**PREPARED TESTIMONY OF RICHARD KUPREWICZ
EVALUATING PG&E'S PIPELINE SAFETY ENHANCEMENT
PLAN**

**CALIFORNIA PUBLIC UTILITIES COMMISSION
PIPELINE SAFETY RULEMAKING
R. 11-02-019**

**Submitted on behalf of
THE UTILITY REFORM NETWORK (TURN)**

Figure 11 – Accufacts’ Valve Decision Tree

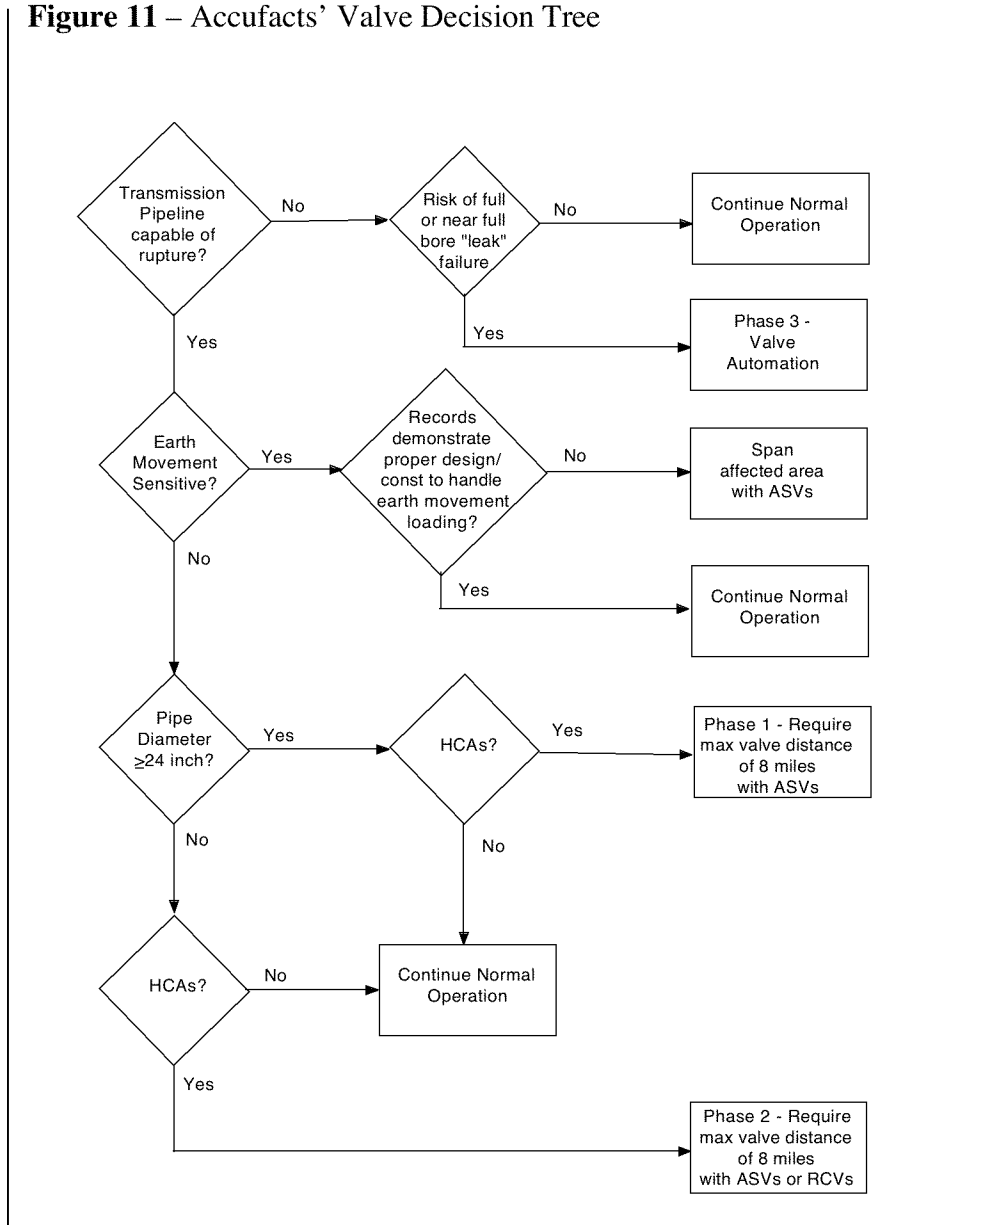
Figure 11 is a more appropriate valve decision tree that TURN recommends should be utilized to determine the prudent placement and automation of valves on gas transmission pipelines. Several important points related to Figure 11 need to be highlighted.

1. Phase 1 should install ASVs spaced at a maximum of eight miles on all pipelines equal to or greater than 24 inches spanning HCAs.
2. Phase 2 should install ASVs or RCVS at a maximum spacing of eight miles on all pipelines less than 24 inches spanning HCAs.
3. Phase 3 should install valve automation on remaining low pressure transmission pipelines that are at risk of a full bore “leak failure” such as poor girth welds.

Figure 12– PG&E’s Proposed Phase 1 Valves by Pipe Diameter and Pipe Miles in Class 3 and 4 and 4

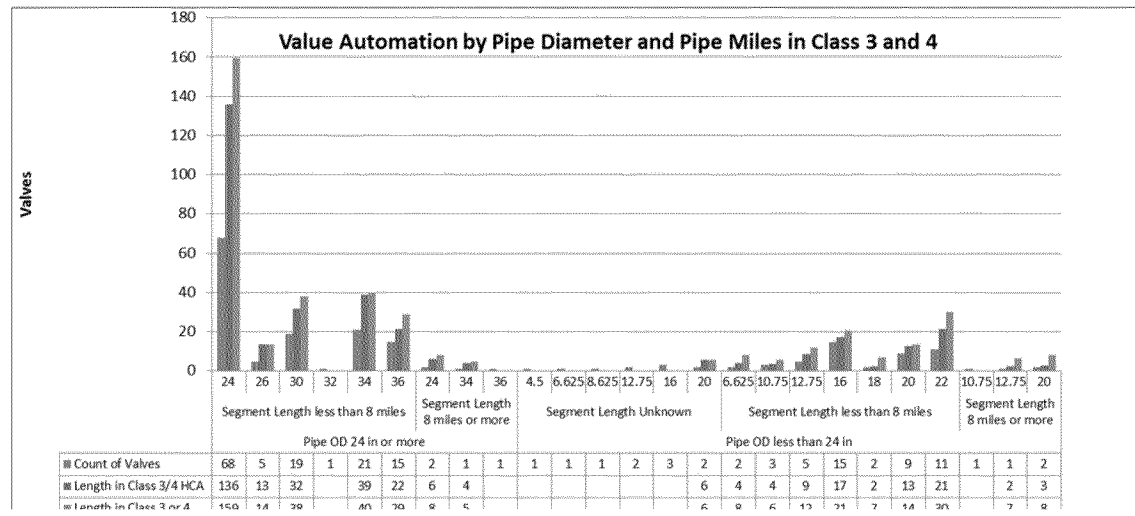
In addition Figure 12 provides a more detailed analysis of the PG&E proposed 194 valves in their proposed Phase 1. Figure 12 indicates that 61, or approximately one-third of PG&E's proposed valves, would be on lines less than 24 inch in diameter.⁶⁶

Figure 12 also indicates that four of the Phase 1 proposed valves on the larger diameter pipelines have valve spacing greater than 8 miles. TURN believes a closer study of the specific location of these four valves is warranted, though the isolation blowdown may not change significantly. A review of Figure 7 indicates that isolation blowdown times for smaller diameter lines will prevent even ASVs from meeting the 30 minute responder goal for valve spacing of eight miles. Fortunately, smaller diameter pipelines produce much smaller potential impact zones following a rupture than their larger diameter counterparts during longer duration burns.

Figure 13: PG&E Pipeline Replacement, 1985-2010

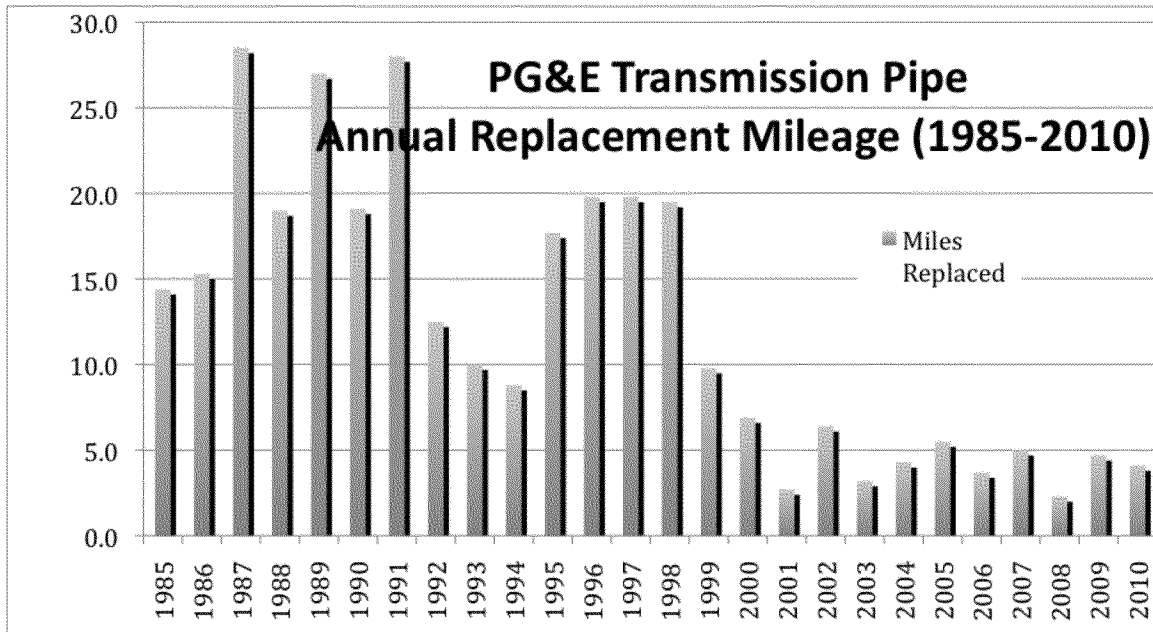
The above Figure strongly suggests that PG&E's misplaced reliance on DA caused it to significantly curtail pipeline replacement. PG&E's IP now appears to be an effort to play catch-up.
